**PR/0191/22**

## **Record of Executive Business and Chief Executive's Order**

**Reg. Reference:** SD21A/0333      **Application Date:** 09-Dec-2021  
**Submission Type:** New Application      **Registration Date:** 09-Dec-2021

**Proposed Development:** Demolition of existing garage to side; construction of  
new 2 storey dwelling to the side of the existing  
dwelling; new storm water percolation area to rear;  
new car parking provision for 2 vehicles accessible  
from Heatherview Avenue; associated site works.

**Top:** Extract from SDCC maps showing areas taken in charge in yellow. Note No. 50 is the subject site. **Bottom:** Screenshot of Property Registration Authority Maps, with land parcel of No. 50 highlighted. Neither is guaranteed to provide an accurate representation of land ownership.

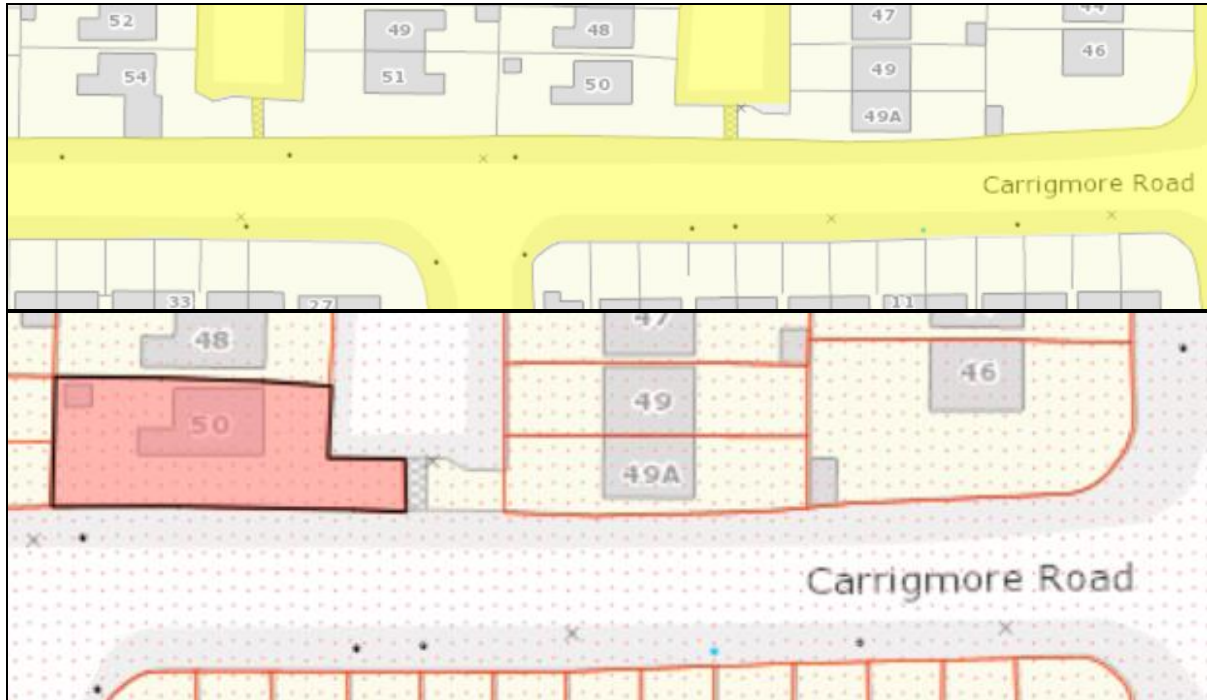
South Dublin County Council maps show a strip of land between Nos. 50 and 49A to have been taken in charge by South Dublin County Council, reflecting either a previous pedestrian connection or a route for services. A similar feature is noted on Heatherview Park, where a walled in strip of land is retained and contains a lamp post. It is possible that these were pedestrian connections which were blocked up.

Measurements taken from aerial photograph appear to show the applicant's boundary being approx. 13.2m from the front building line of the existing garage; however, the site layout plan and floor plans taken together show a measurement of 14.2 metres between this same point and the far edge of the vehicular access (1.7m front projection at ground level and 12.789m distance marked on layout plan between front of house and edge of site). There is therefore a question as to whether the proposed development would include the enclosure of SDCC owned lands.

The applicant should be invited to comment on the ownership boundary by way of **additional information**.

pedestrian connections which were blocked up. Having measured the proposed plans and taking measurements from the Site Layout Plan, it is considered that the proposed development might include the enclosure of lands in the ownership of South Dublin County Council (see Planner's report for details). The applicant is requested to comment on the ownership boundary and provide revised plans if appropriate, or as per part (b). (b) Under Policy Tm3 Objective 2 of the South Dublin County Development Plan 2016 - 2022, it is an objective of the council to ensure that connectivity for pedestrians and cyclists is improved in existing areas, while minimising opportunities for anti-social behaviour and respecting the wishes of local communities. It is considered that a pedestrian connection at this location would be successful if combined with a lowering of the boundary wall between the front building line of the proposed house and the site boundary with No. 49, to provide visual penetration through the site and ensure a potential pedestrian through route is open and subject to local passive surveillance. (c) It appears from the drawings submitted that flashing at roof level on the gable elevation might overhang the public realm / SDCC lands. The applicant is invited to comment on this and confirm that the development will not overhang the public realm / SDCC lands, and provide revised drawings if necessary.
